RESPONSE TO REQUEST FOR ADDITIONAL INFORMATION

APR1400 Design Certification

Docket No. 52-046

RAI No.: 287-8272
SRP Section: 09.01.02 – New and Spent Fuel Storage
Application Section: 9.1.2
Date of RAI Issue: 11/02/2015

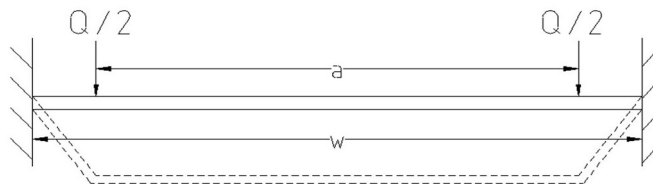
1. The 10 CFR Part 50, Appendix A, General Design Criteria (GDC) 1, 2, 4, 5, 63, and 10CFR 52.80 (a) provide the regulatory requirements for the design of the new and spent fuel storage facilities. Standard Review Plan (SRP) Sections 9.1.2 and 3.8.4, Appendix D describes specific SRP acceptance criteria for the review of the fuel racks that are acceptable to meet the relevant requirements of the Commission's regulations identified above. The SRP 3.8.4 Appendix D section I (3), "Seismic and Impact Loads" requires that "Because of gaps between fuel assemblies and the walls of the guide tubes, additional loads will be generated by the impact of fuel assemblies during a postulated seismic excitation. Additional loads resulting from this impact effect may be determined by estimating the kinetic energy of the fuel assembly. The maximum velocity of the fuel assembly may be estimated to be the spectral velocity associated with the natural frequency of the submerged fuel assembly. Loads thus generated should be considered for local as well as overall effects on the walls of the rack, the supporting framework. It should be demonstrated that the consequent loads on the fuel assembly do not lead to damage of the fuel." In order for the staff to perform its safety evaluation of the racks for impact loads, the applicant in accordance with SRP 3.8.4 Appendix D I.3, is requested to provide the details of how the additional loads due to the impact of fuel assemblies during a postulated seismic excitation are computed and how these loads are considered in the analysis and design of the walls of the rack and supporting framework and demonstrating the structural integrity of the fuel.

The additional loads due to the impact of fuel assemblies during a postulated seismic excitation are computed from the reaction loads on the spring-mass elements of the fuel assembly-to-cell wall by dynamic analysis. The maximum impact load of the fuel support grid is calculated by dividing the maximum impact load (25,000 lbf) per cell by the number of spacer grids (11 ea), which is shown on the Table 3-10 in the report APR1400-H-N-NR-14012-P. All the fuel assemblies in each storage rack module are modeled as one beam of of

The design check of the cell wall for the fuel assembly impact load is performed by comparing the maximum calculated impact load obtained from the computer code ANSYS with the limit load for an individual cell wall.

The limit load for an individual cell wall is determined on a beam strip (the width of a single cell), which is subject to impact loads simulating two corners of a fuel assembly. The collapse load on structure of the panel shape can be explained by the collapse due to bending. The impact of fuel-to-cell wall is assumed to occur over a vertical dimension along the cell wall.

The limit load for an individual cell wall calculated using the above formula is 10,660 lbf. It is much larger than the maximum impact load of fuel support grid (2,273 lbf) given in Table 3-10 in the report APR1400-H-N-NR-14012-P. Therefore, the stresses in the cell membrane are acceptable for the postulated fuel impact.

Deformed Shape of the Rack Baseplate

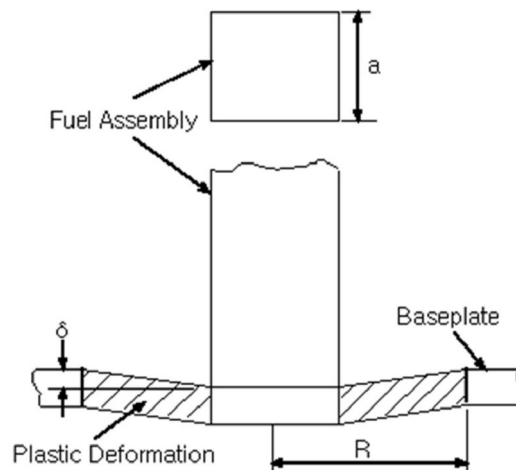
1. The 10 CFR Part 50, Appendix A, General Design Criteria (GDC) 1, 2, 4, 5, 63, and 10CFR 52.80 (a) provide the regulatory requirements for the design of the new and spent fuel storage facilities. Standard Review Plan (SRP) Sections 9.1.2 and 3.8.4, Appendix D describes specific SRP acceptance criteria for the review of the fuel racks that are acceptable to meet the relevant requirements of the Commission's regulations identified above. In DCD Tier 2, Section 9.1.2.2.3, "New and Spent Fuel Storage Rack Design", the applicant stated that "The dynamic and stress analyses are performed as described in report APR1400-H-N-NR-14012-P & NP". In the report APR1400-H-N-NR-14012-P, Rev.0, Section 4.1 "Description of Mechanical Accident", the applicant considered a drop of fuel assembly in an interior cell away from the support pedestal for one of the 'Straight Deep Drops' scenario. The applicant is requested to provide specific location(s) of the drop on the rack base plate that were considered to maximize the deformation of the rack base plate and whether it also considered a deep drop into a cell along the perimeter and half way between the supports. It is not clear from the description whether the rack baseplate evaluation due to fuel impact assumed that other fuel assemblies are in place when a fuel assembly drops through an empty cell. A full load of fuel assemblies may introduce progressive deformation of the baseplate after a fuel assembly impacts the rack baseplate. The maximum downward deformation of the baseplate may be significant enough to initiate a progressive deformation. Therefore, the applicant is also requested to provide (1) the technical basis and justification for not considering all other fuel assemblies in place when a fuel assembly drops through an empty cell and (2) the design basis for the rack baseplate including the basis for determining the most critical locations of the fuel assembly drop.

- (1) The calculated deflection of the baseplate due to the deep drop conservatively ignores the reinforcing effect of the cell-to-baseplate welds. The strength provided by the cell-to-baseplate weld reinforcement would offset the added static load of the fuel assemblies. Therefore, all other fuel assemblies in place is not considered when a fuel assembly drops through an empty cell.
- (2) When a fuel assembly drops to the baseplate of a rack, the baseplate must not experience gross failure (i.e., puncture), and the deformed baseplate must not impact the pool liner. In the deep drop analysis (away from the pedestal), a specific location on the rack baseplate was not considered because the maximum deformation of the rack baseplate is calculated without a support under the rack baseplate.

The figure below shows the final deformed shape of the baseplate considered in deep drop analysis.
